2. ACTION ITEM: Recommendation to review and recommend approval to the City Council the Cedars Townhomes Preliminary Plat application, as conditioned, and adopt the Findings of Fact, Conclusions of Law, and Decision.

3. ACTION ITEM: Recommendation to review and approve the 450 Wood River Drive Residence Floodplain Development Permit application, as conditioned, and direct staff to return with the findings of fact.

**STAFF REPORT  
KETCHUM PLANNING & ZONING COMMISSION  
REGULAR MEETING OF MAY 28, 2024**

**STAFF REPORT**  
**KETCHUM PLANNING AND ZONING COMMISSION**  
**MAY 28, 2024 MEETING**

3 1/8" = 1'-0" **BUILDING SECTION - LIVING N-S**

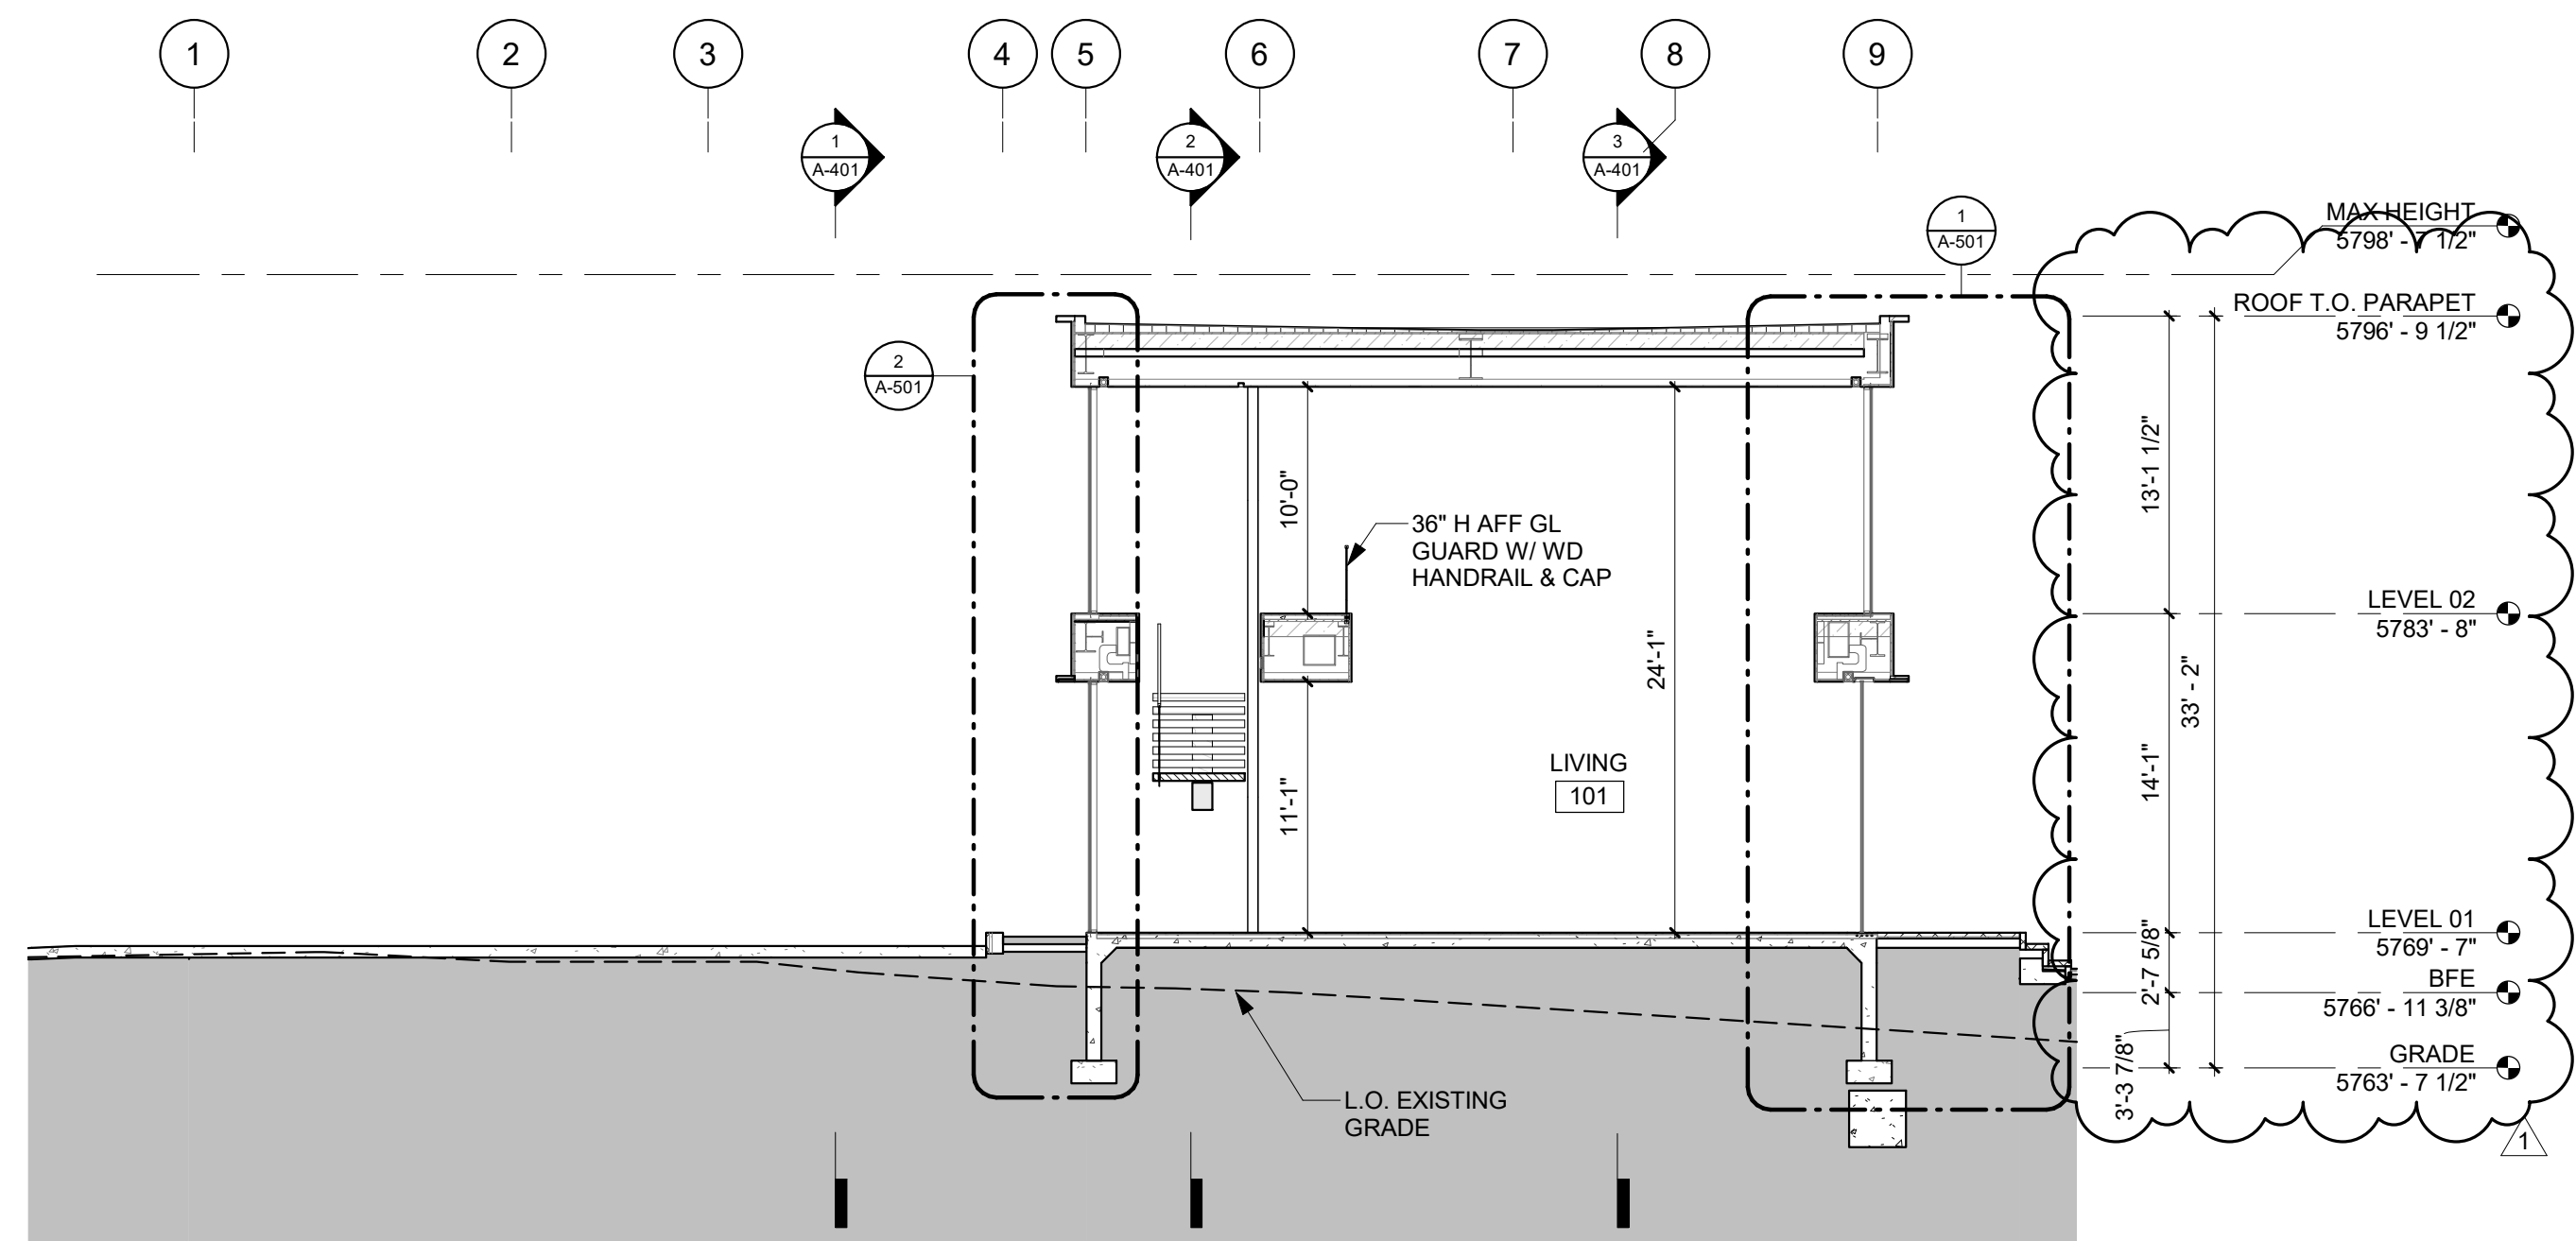
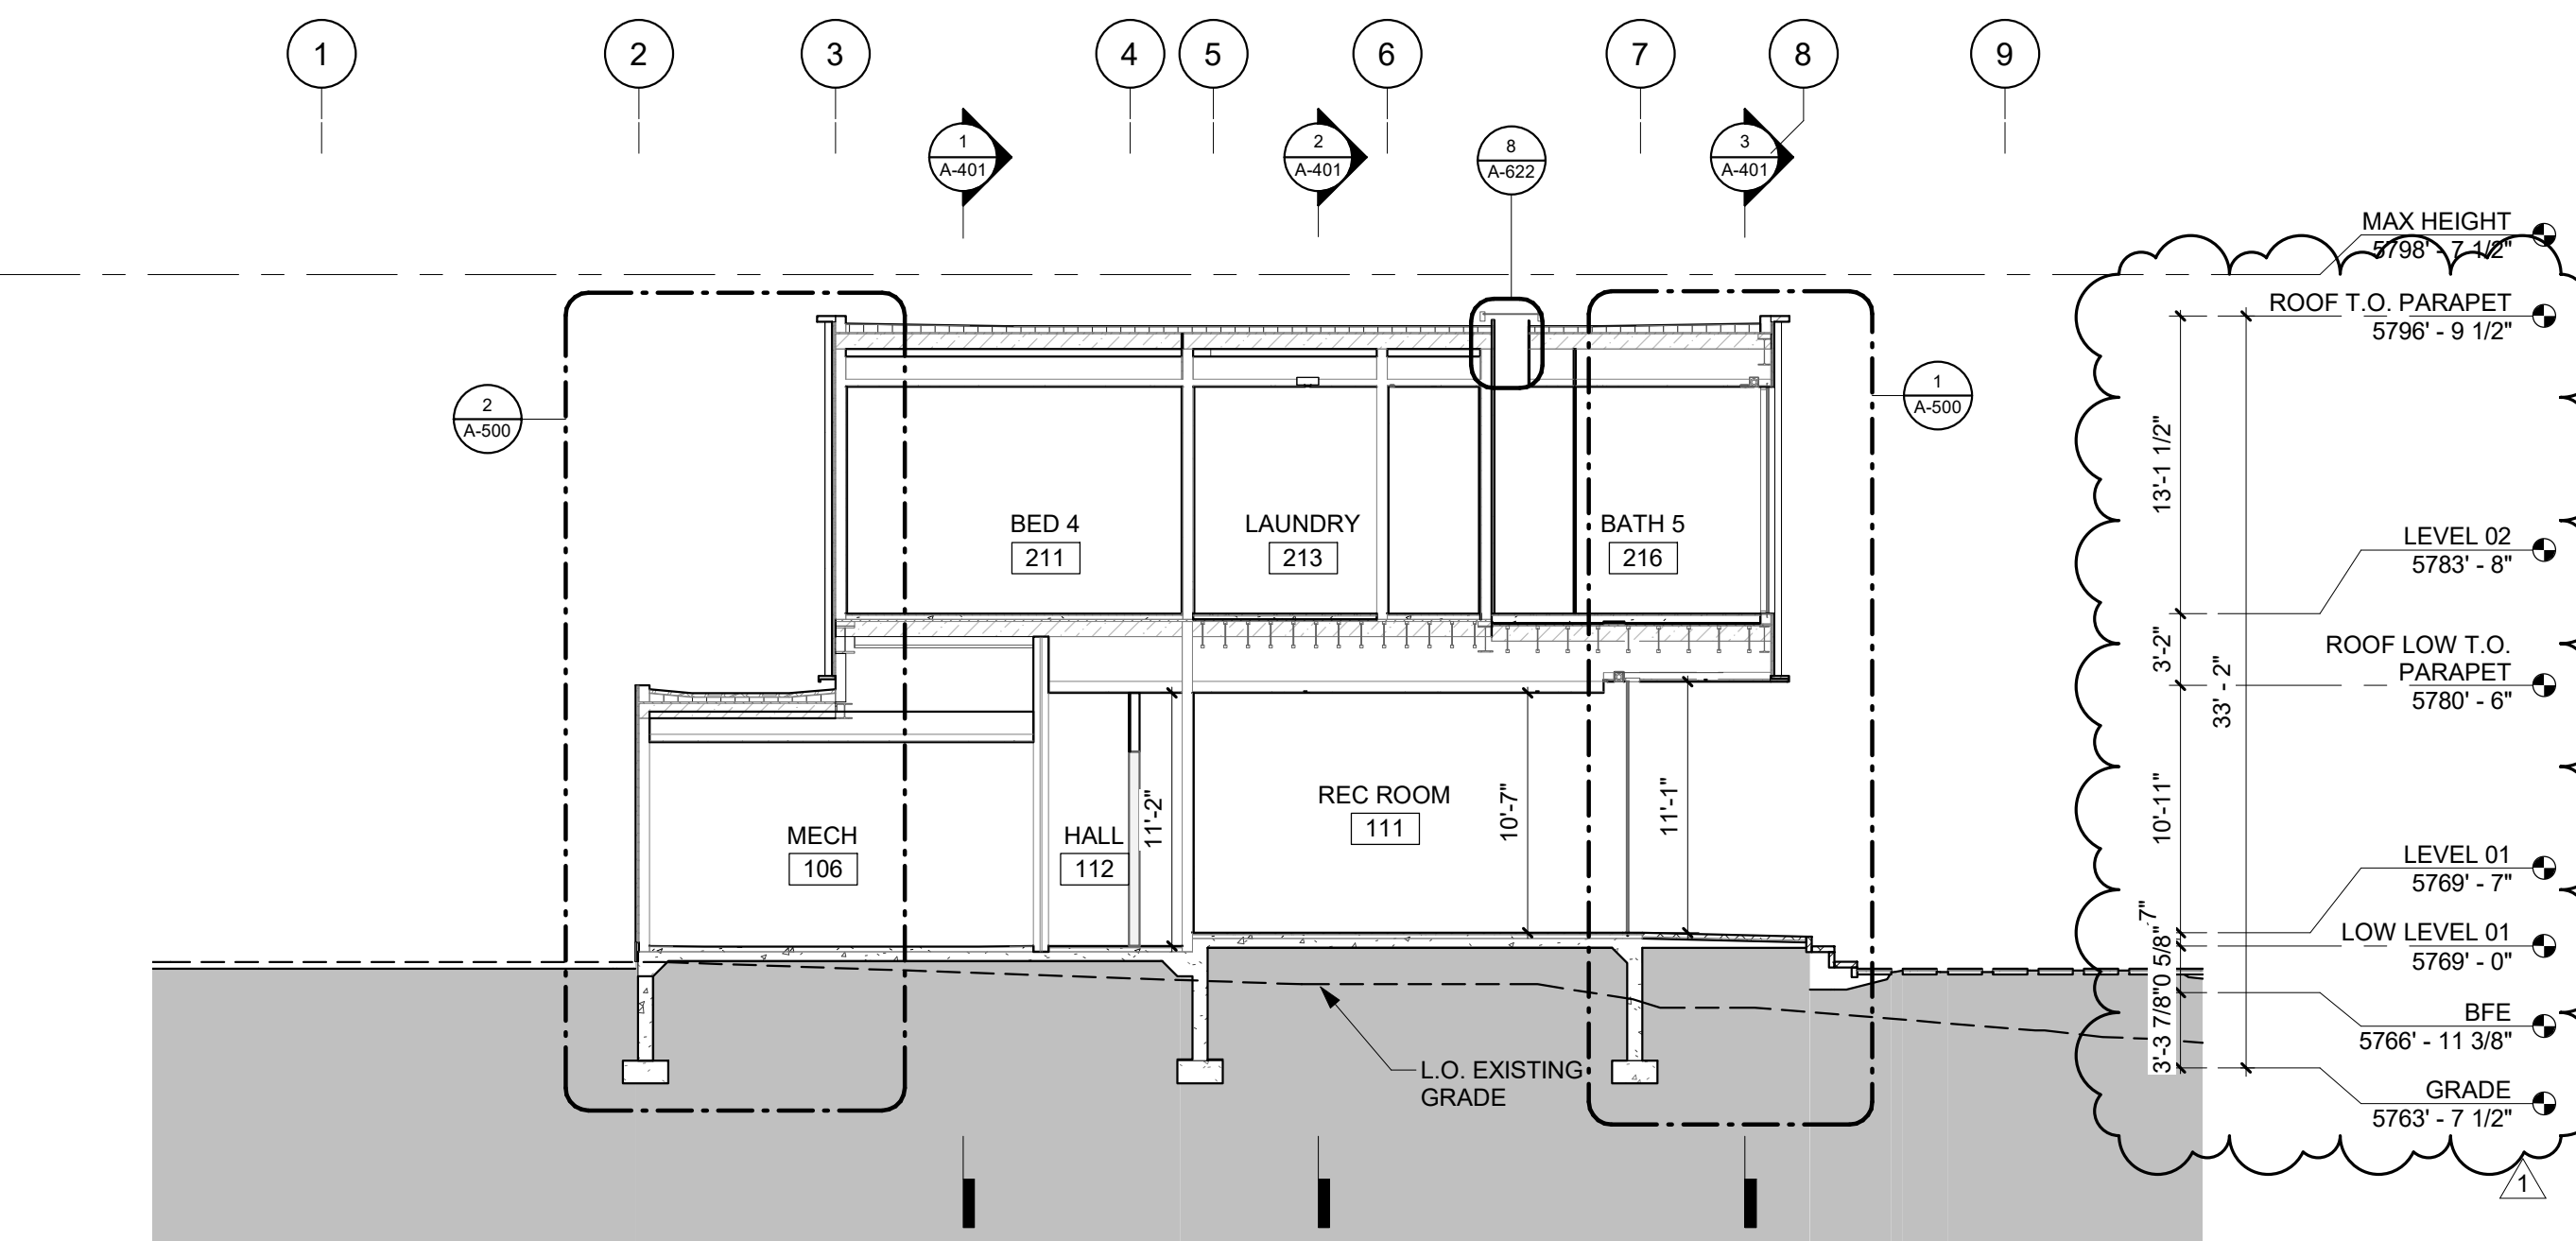
<i>Staff Comments</i>	<i>The top of the lowest floor (finished floor) is elevated 24" above the Base Flood Elevation of 5766.95 as shown on Sheets A-400 &amp; A-401. As the proposed elevation is located within the AE zone the top of the lowest floor is required to be 24" above the BFE.</i>
<input checked="" type="checkbox"/>	<input type="checkbox"/>	<input type="checkbox"/>	17.88.050(E)10	<p>The backfill used around the foundation in the SFHA floodplain shall provide a reasonable transition to existing grade but shall not be used to fill the parcel to any greater extent.</p> <p>a. Compensatory storage shall be required for any fill placed within the floodplain.</p> <p>b. A CLOMR-F shall be obtained prior to placement of any additional fill in the floodplain.</p>
			<i>Staff Comments</i>	<i>Backfill used around the foundation which provides a reasonable transition to existing grade is not considered as part of the compensatory storage requirement. The proposed cut on the site is 638.1 cubic yards while the proposed fill not associated with the residence is 265.4 cubic yards, resulting in a net cut-fill balance of 372.7 cubic yards. The proposed cut occurs around modified drainage channels and wetlands which are hydraulically connected to the Big Wood River.</i>
